**RESPONSE TO SPP REPORT NO. PPSSSH-11 (DEVELOPMENT APPLICATION NO. 19/0786)
DEMOLITION OF EXISTING STRUCTURES, CONSTRUCTION OF A MEDICAL CENTRE
398-402 KINGSWAY & 27 FLIDE STREET**

ANNEXURE A – PLANS DEMONSTRATING REQUESTED AMENDMENTS TO DEFERRED COMMENCEMENT CONDITIONS

HEALTH SERVICES FACILITY
398-402 KINGSWAY + 27 FLIDE STREET CARINGBAH NSW 2229

BASEMENT 01 (LOWER GROUND)
PLAN / 1
1

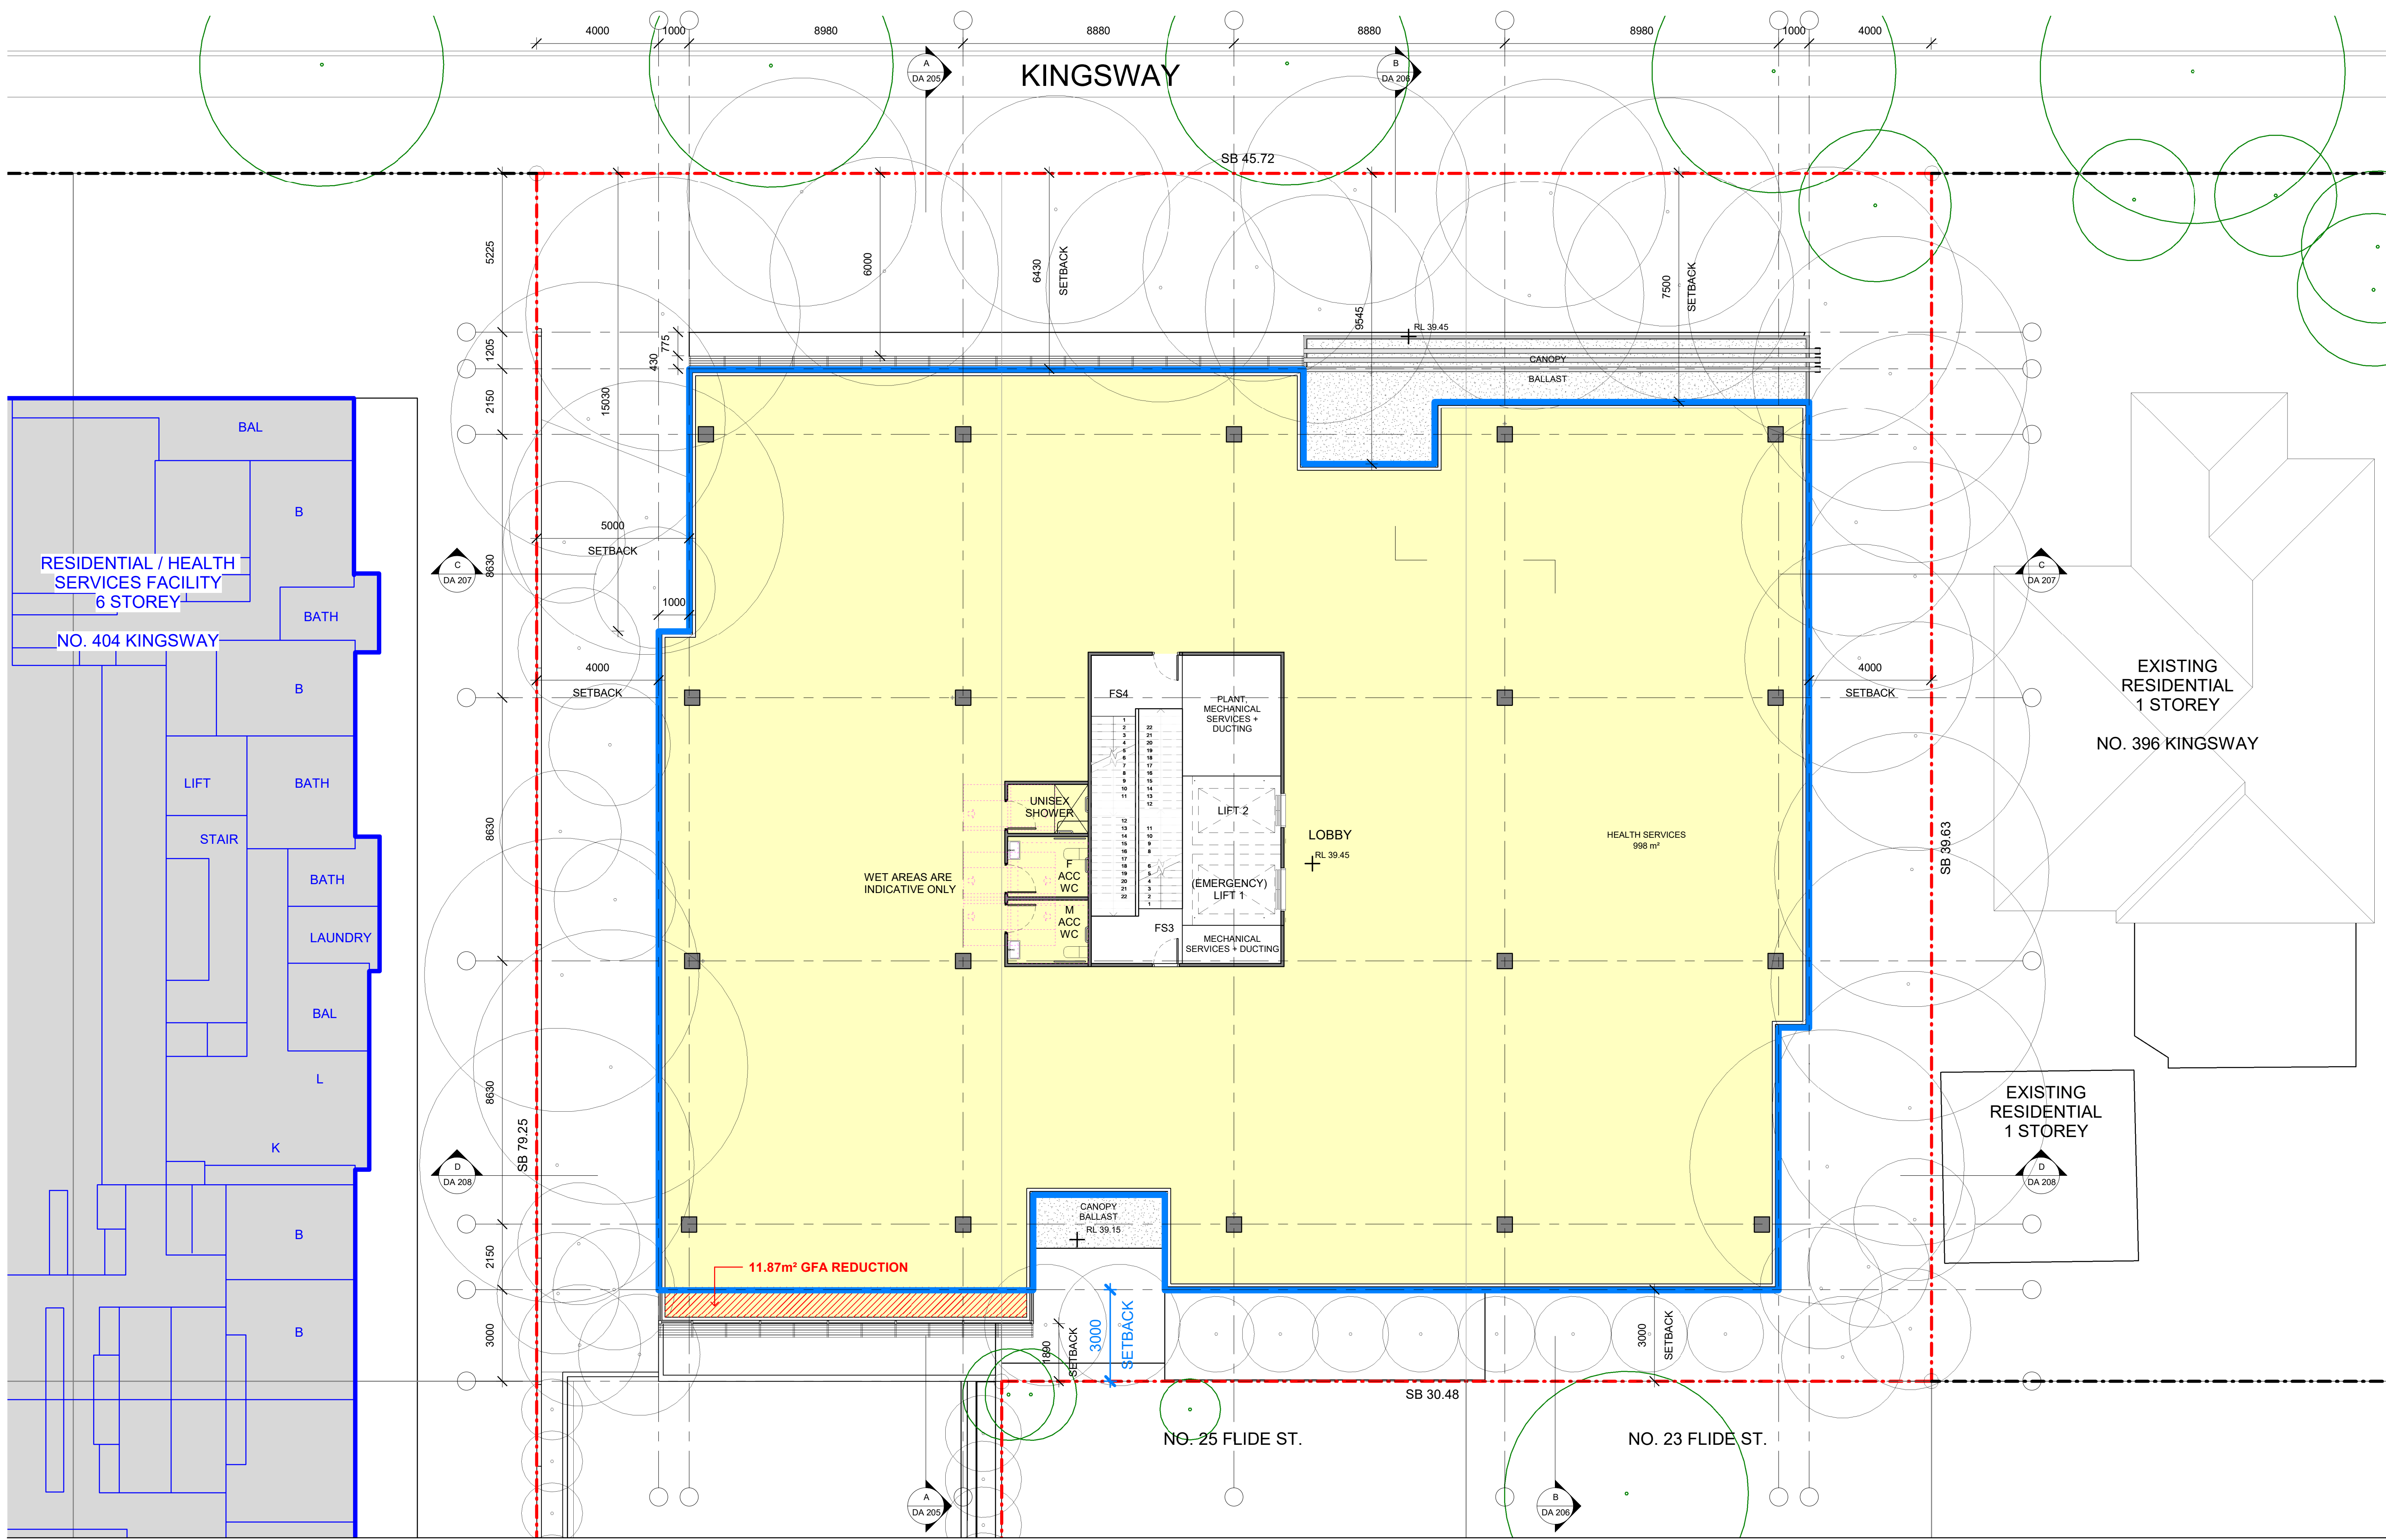
- *Basement Level 01 (Lower Ground) ~~All basement levels~~ of the building must be setback 3m from the rear boundary.*

- *A 3m deep soil landscape setback must be provided from the rear boundary in the setback area to Basement Level 01 (Lower Ground), above Basement Level 02.*
- *The area shown as service parking spaces should be replaced with deep soil landscaping.*

As indicated, it is requested that the deferred commencement condition be modified to require a 3m setback to Basement Level 1 which enables planting of 11 trees in deep soil that will grow to provide a significant vegetated separation to the sites to the south. In spatial terms, the BEP always envisaged building on this part of the site and therefore in overall urban design and contextual terms, the outcome is acceptable. The proposed fifth level is setback further from the levels below to further assist with minimising building bulk.

LEVEL 03 PLAN

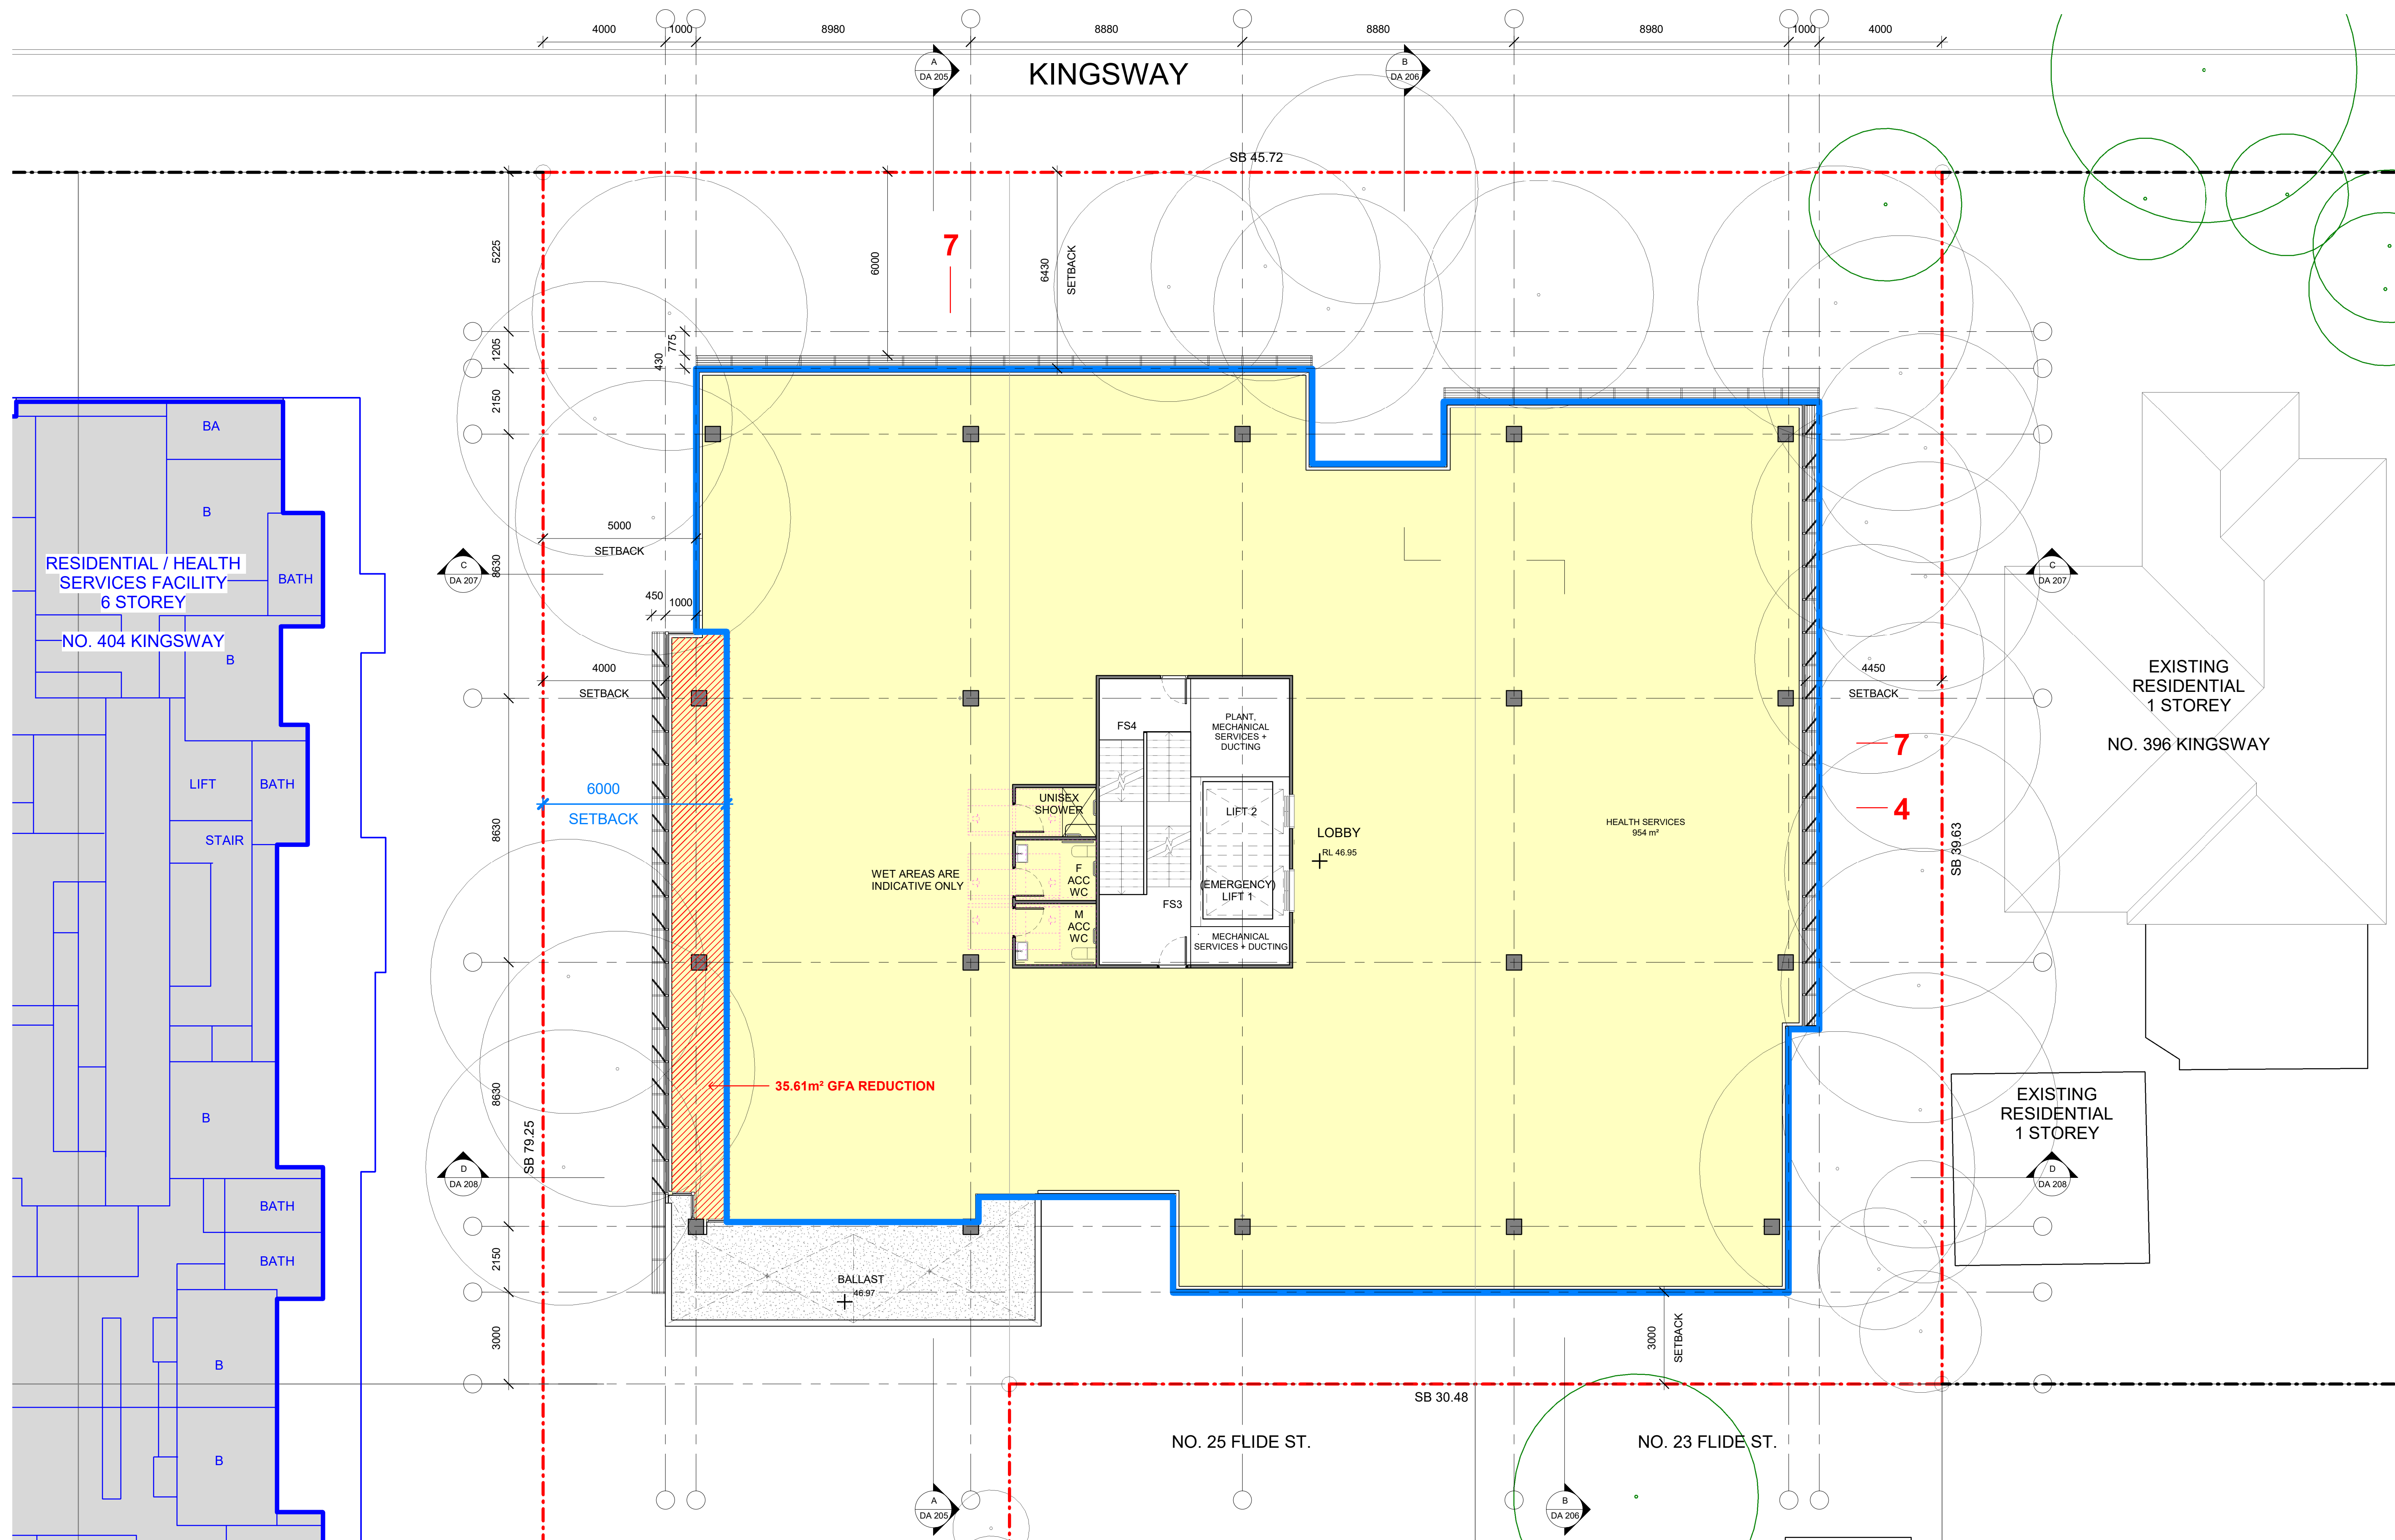
- *The rear south western elevation of the building at Level 03 should be setback 3m from the rear boundary of Nos. 23 and 25 Flide Street, for the entirety of the elevation. ~~from Level 01(Ground) Plan/1 to Level 05 should be setback to meet the habitable to habitable setbacks of the ADG.~~*
